Value Engineering For Wastewater Treatment Works

VALUE ENGINEERING REPORT
XYZ WASTEWATER TREATMENT PLANT
SANITARY DISTRICT
USA
25% DESIGN COMPLETION STAGE

This report summarizes the results of the first value engineering study for the XYZ Wastewater Treatment Plant expansion program.

D4 (JC-5)-1
Sample

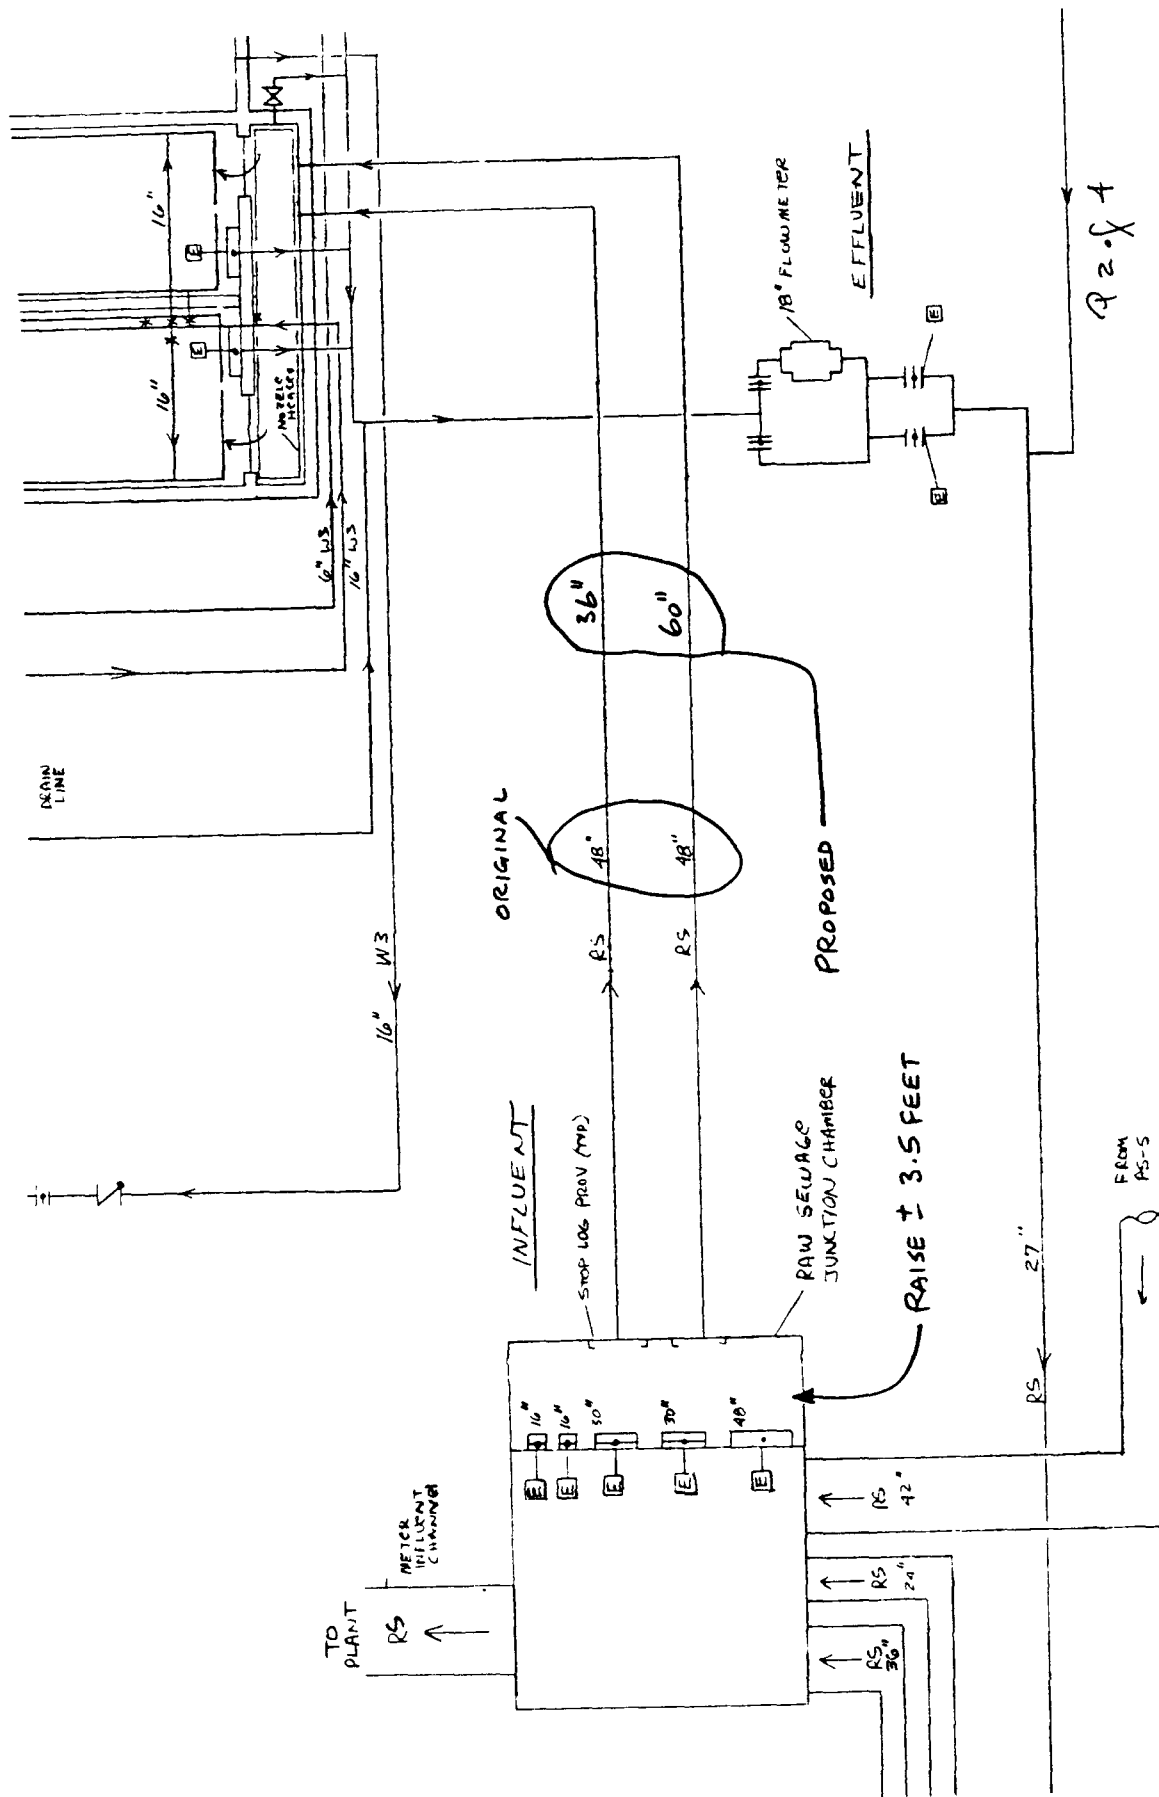
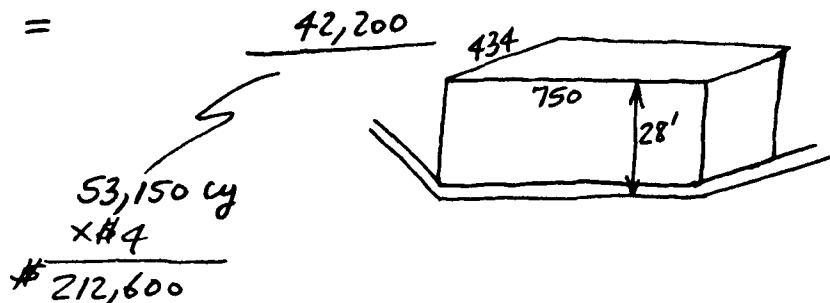
Change the pipeline sizes to 1-36" diameter and 1-60" diameter to reduce headloss from 7 feet at maximum flow conditions to about 3.5 feet. The result is that the tanks may be raised some 3.5 feet. Scouring velocities are maintained by using a smaller pipe for low flow conditions and a larger pipe for higher flows. (See attached sketch JC-5-1)

ASSUME A MAXIMUM OF 2.5' HEADLOSS

$$\therefore 2.5'/1000 = \frac{0.25'}{100} = 66" \phi \text{ at } 90 \text{ MGD}$$

ASSUME A SMALLER PIPE FOR FLOWS UP TO 20 MGD.
USE 36" ϕ .

Q BIG PIPE (60" ϕ) = 90-20 MGD = 70 MGD USE 60" ϕ .

Response
Accepted.
